MIL-R-63997B(AR)
AMENDMENT 4
31 July 1993

SUPERSEDING
AMENDMENT 3
25 March 1992

RIFLE, 5.56MM: M16A2

FIGURE 1. Targeting and accuracy diagram.

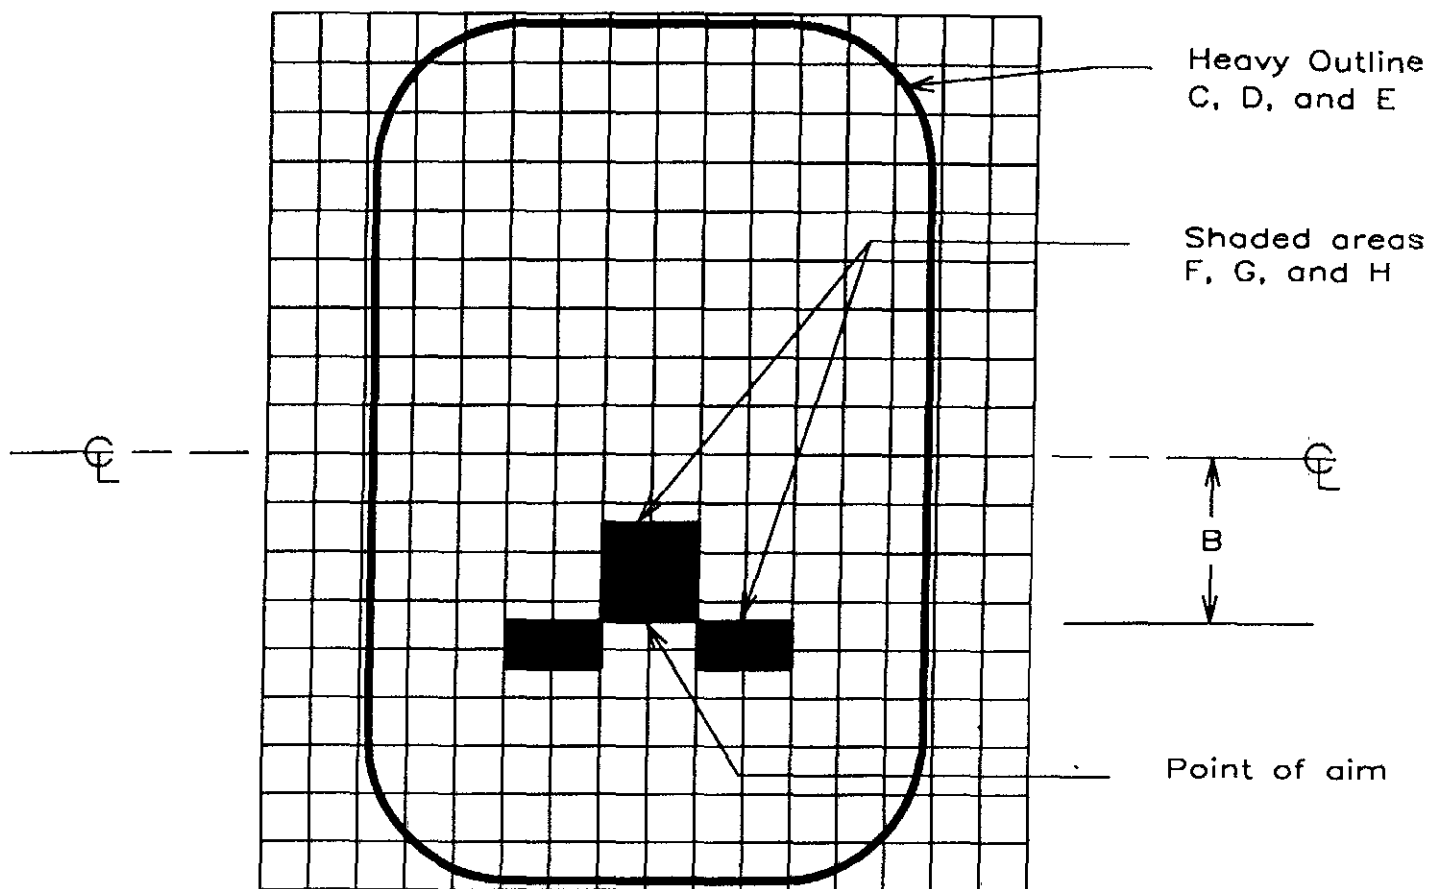
* 3.4.6: Delete in it's entirety and substitute the following:

"3.4.6 Targeting and accuracy. A series of 10 rounds fired from each rifle at a range of 91.4 meters shall be within the extreme spread and targeting area (heavy outline) specified in Figure I when the front and rear sights are set as follows. The normal rear sight peep (sight rotated fully rearward) shall be used with the rear sight set centrally in the slot for windage within plus or minus five (5) clicks. The top edge of the front sight post flange shall be set flush to .030 inch below the bottom surface of the front sight slot. Ammunition shall be Government standard M855, 5.56mm ball cartridges conforming to Drawing 9342868 and shall have a vertical and horizontal standard deviation at 600 yards between 3.4 inches and 4.0 inches when measured in accordance with MIL-C-63989."
